STAGE 4

Archer Humphryes Architects

project title	
KOKO + Hope & Anchor + Bayham Place, Camden, London	
drawing title	scale / date
Proposed Ground Floor Plan	1:100 @ A1 13.04.17
drawing number	drawn / checked
AHA/KKC/GA/100	FR/PC DA
	revision
	C

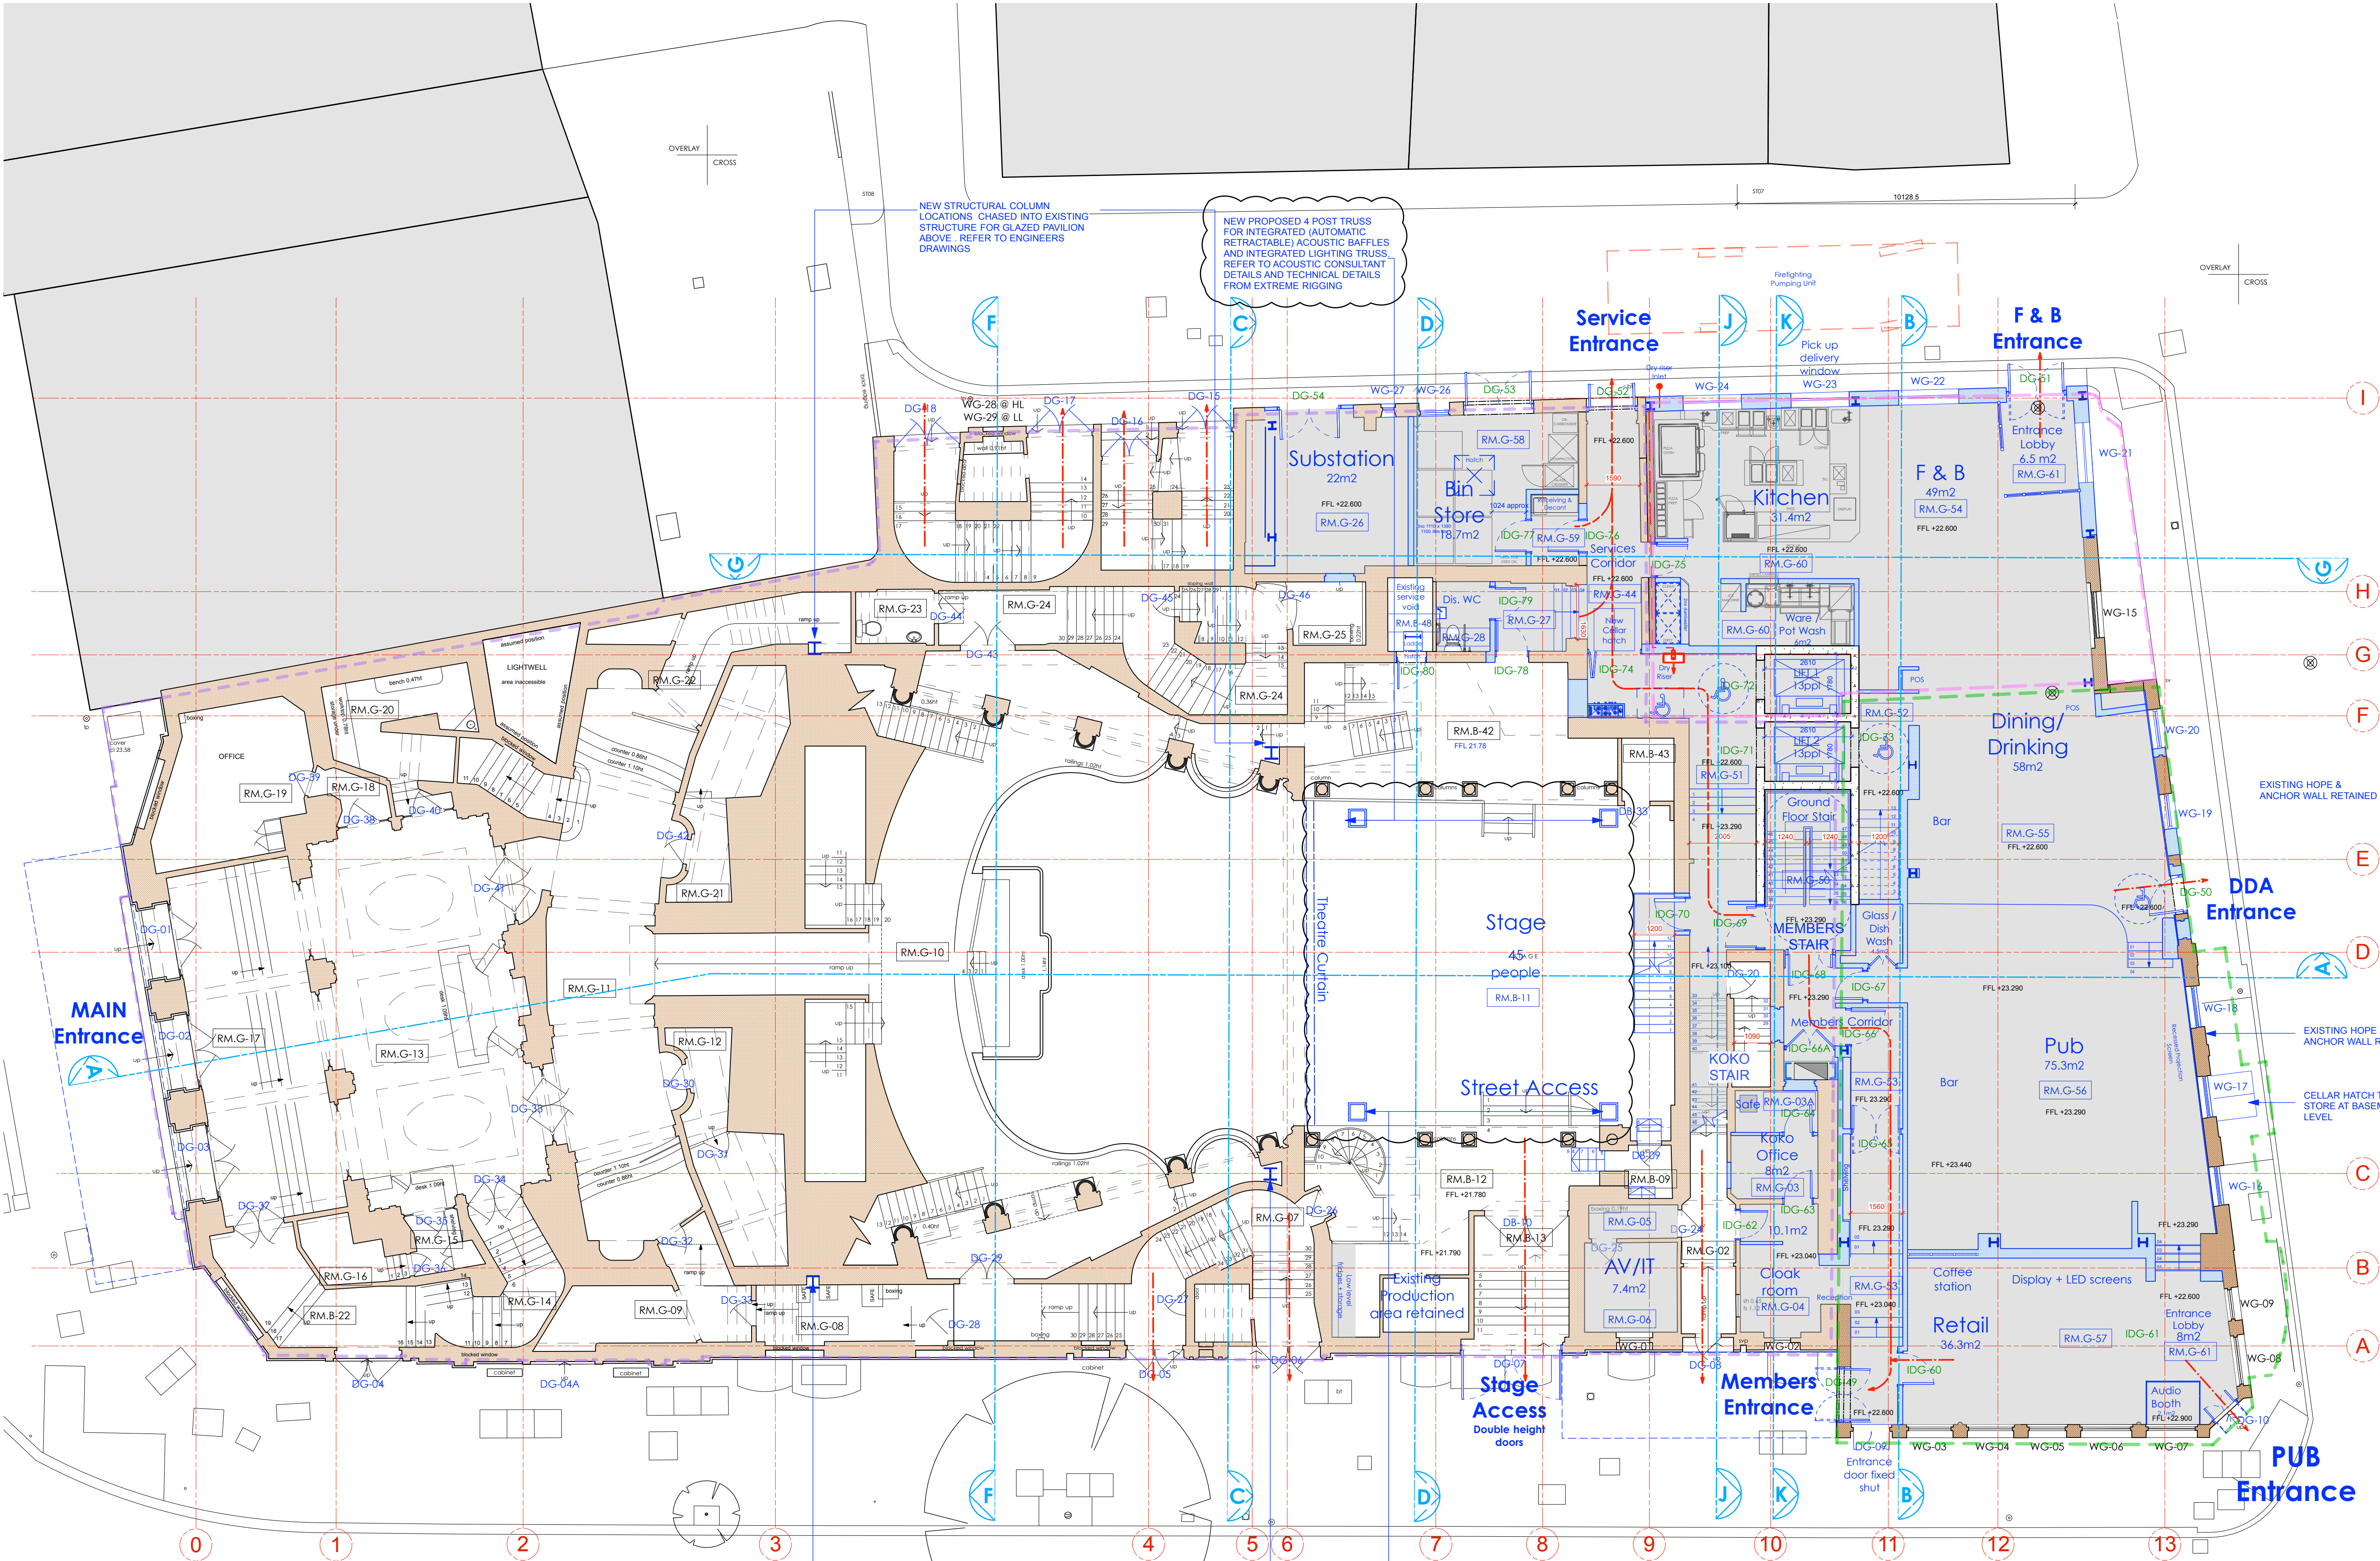
revision / date / amendments		
- / 26/01/18 /	A / 23/03/18 /	- First Issue 1. Tender Addendum (1), indication of 4 post truss fixed at stage level for integrated automatic retractable acoustic baffles and integrated lighting rig. 2. Tender Addendum (2), New AHU + Attenuator over stage to be hung to existing relocated secondary beams in flytower. - Door and window numbers updated Listed Building Application 1. Indication of 4 post truss fixed at stage level for integrated automatic retractable acoustic baffles and integrated lighting rig. 2. New AHU + Attenuator over stage to be hung to existing relocated secondary beams in flytower.
B / 12/04/18 /	C / 01/06/18 /
